MIL-PRF-19500/795
w/AMENDMENT 1
25 February 2026
SUPERSEDING
MIL-PRF-19500/795
16 May 2025

PERFORMANCE SPECIFICATION SHEET

TRANSISTOR, FIELD EFFECT RADIATION HARDENED, N-CHANNEL,
SILICON, TYPES 2N7645, QUALITY LEVELS JANTXV AND JANS

FIGURE 2. Dimensions and configuration (Similar to SMD-0.2), with ceramic lid (U8CE).

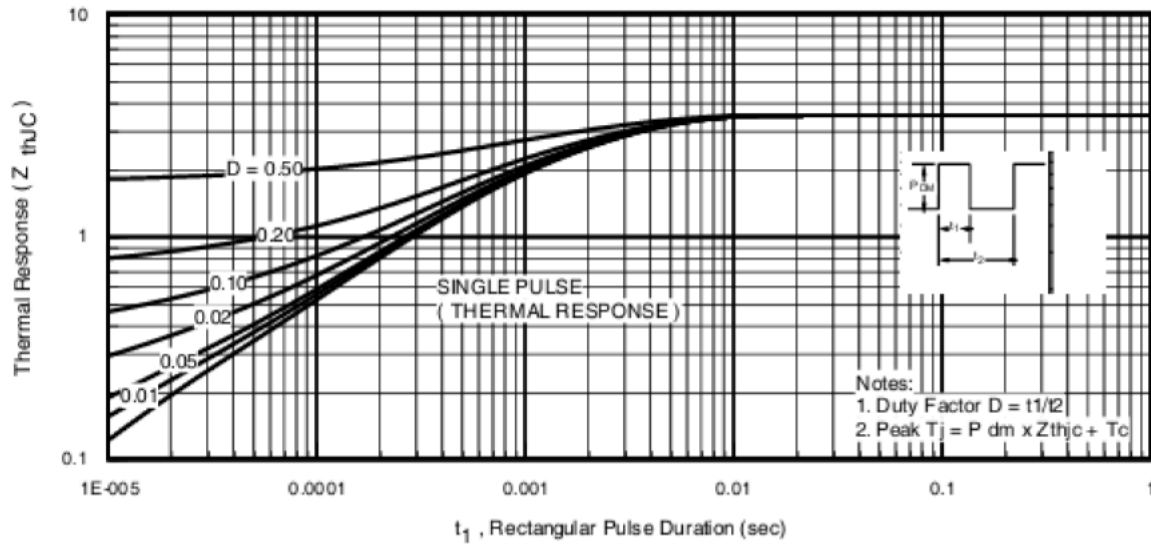
* 1.2 Package outlines. The device package outlines are as follows: surface mount SMD-0.2, U8C (ceramic lid) suffix in accordance with [figure 1](#), surface mount SMD-0.2, U8CE (ceramic lid) suffix in accordance with [figure 2](#), for all encapsulated device types.

U8C	Indicates a ceramic lidded 3 pad surface mount package (SMD-0.2) (see figure 1).
U8CE	Indicates a ceramic lidded 3 pad surface mount package with enhanced PCB mount features, similar to a SMD-0.2 (see figure 2)

*

Symbol	Dimensions			
	Inches		Millimeters	
	Min	Max	Min	Max
BL	.300	.310	7.62	7.87
BW	.205	.215	5.21	5.46
CH		.097		2.46
LH	.010	.020	0.25	0.51
LW1	.180	.190	4.57	4.83
LW2	.068	.078	1.73	1.98
LL1	.161	.171	4.09	4.34
LL2	.068	.078	1.73	1.98
LS1	.121	BSC	3.07	BSC
LS2	.061	BSC	1.55	BSC
LS3	.044	BSC	1.12	BSC
LS4	.167	BSC	4.24	BSC
Q1	.030		0.76	
Q2	.030		0.76	
TERM 1	Drain			
TERM 2	Gate			
TERM 3	Source
